**Re: Bottle Rock Power Plant - 79-AFC- 4  
Responses to Data Requests**

**PETITION TO AMEND FINAL DECISION TO RE-FIRE PLANT  
BOTTLE ROCK POWER PLANT  
79-AFC-4C**

**RESPONSES TO CEC DATA REQUESTS**

ATTACHMENT to RESPONSE #2

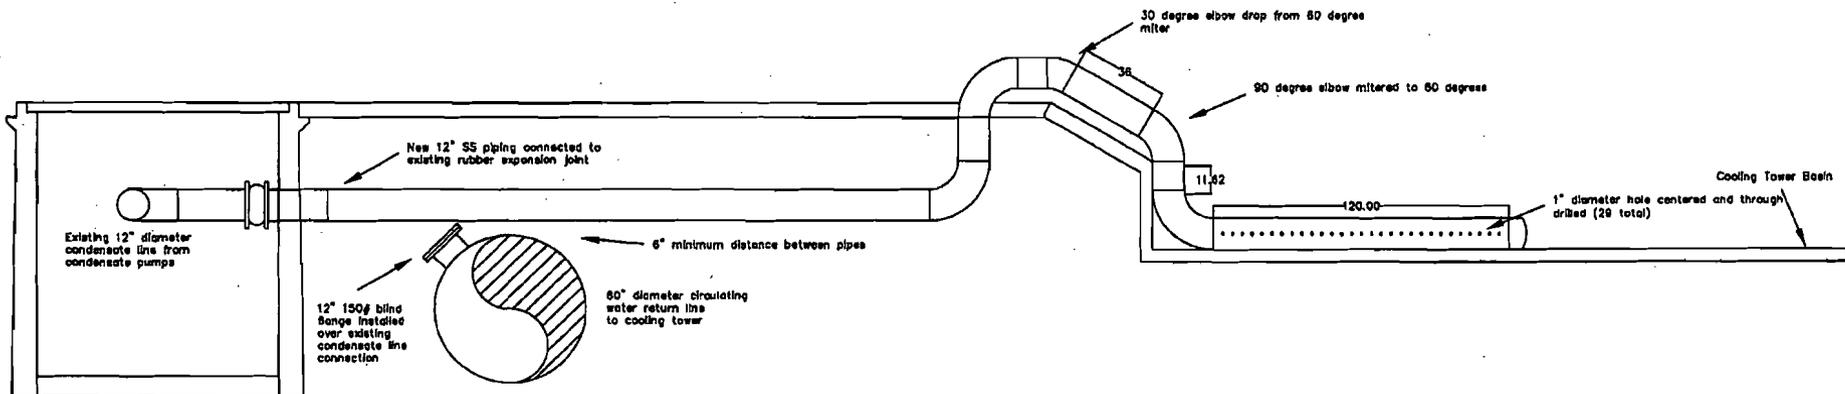
**REQUEST #2: Please provide a BRPP site plan showing the location of the proposed hot condensate pipeline and the location of any other soil disturbing activities planned during plant refurbishment.**

RESPONSE #2: Bottle Rock Power, LLC plans one (1) soil disturbing activity as part of refurbishing the Bottle Rock Power Plant for re-firing. The activity will provide the requisite trench for re-routing the hot condensate line so it can terminate in the cooling tower basin. This section of the hot condensate pipe must pass under the paved roadway that sets between the exiting concrete trench and the cooling tower.

The re-route pipeline is twelve inches in diameter. The applicable regulations mandate that the excavation must be at least twice the pipe diameter with respect to width and depth of the trench. Hence, the excavation will be approximately two feet wide by four feet deep by twenty feet long. The depth of four feet is necessary to accommodate the penetration of the existing hot condensate line through the existing concrete-lined trench. This new trench will yield approximately three cubic yards of excavated soil. See attached Drawing for pipeline and excavation perspective.
